re: Geotechnical Excavation Review

**Proposed Residential Development**

489 & 495 Duvernay Street - Ottawa, Ontario

date: October 2, 2023 file: PG6835-MEMO.01

Geotechnical Excavation Review	Job No.: PG6854
489 Duvernay Street, Ottawa, ON	Date: September 29, 2023
Figure 4 - Section A-A	Dwn: MA
Drawing is not to scale	Page: 1 of 1

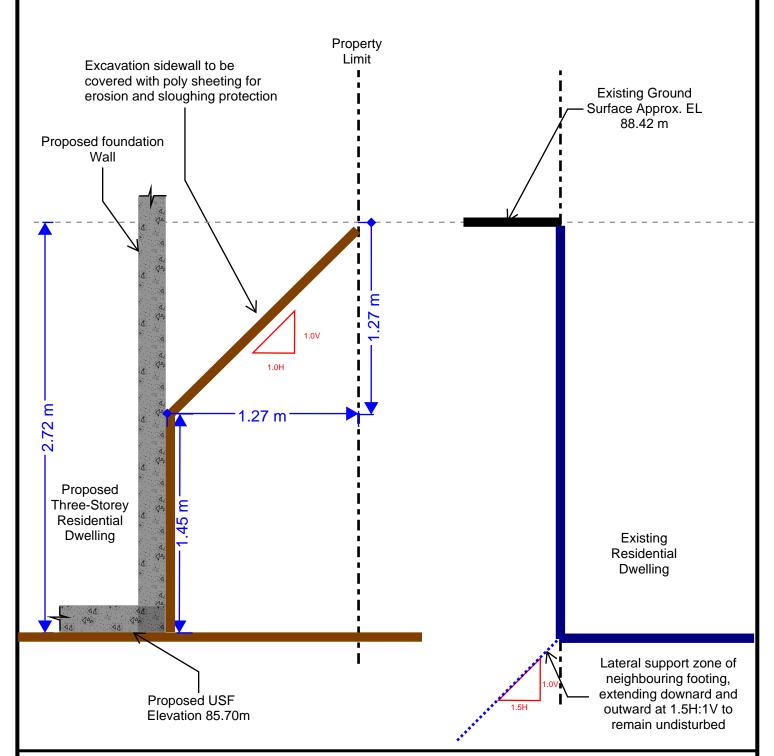
· Confirmation of which system is proposed: sloped excavation or shoring.

· Where proposing a sloped excavation, plan of excavation including gradient

• Comment on adjacent angle of repose and slope stability, where adjacent structure is near the property line.

From our review of the available drawings, the proposed development is sufficiently setback from the property lines to allow for the lower 1.5 m of the excavation to be vertical, and then sloped at 1H:1V above this. The limits of the excavation are shown on the attached Figure 2, and the slope cross-section is illustrated on the attached Figure 3 – Section A-A.

The overburden soils will be sloped back from the excavation, as shown on the attached Figure 3, therefore a shoring system will not be required.

See the attached Figure 2 for the plan of excavation, and Figure 3 for the sloping details.

The neighbouring building to the north has a basement level, therefore the proposed excavation will not extend within the angle of repose of this adjacent structure
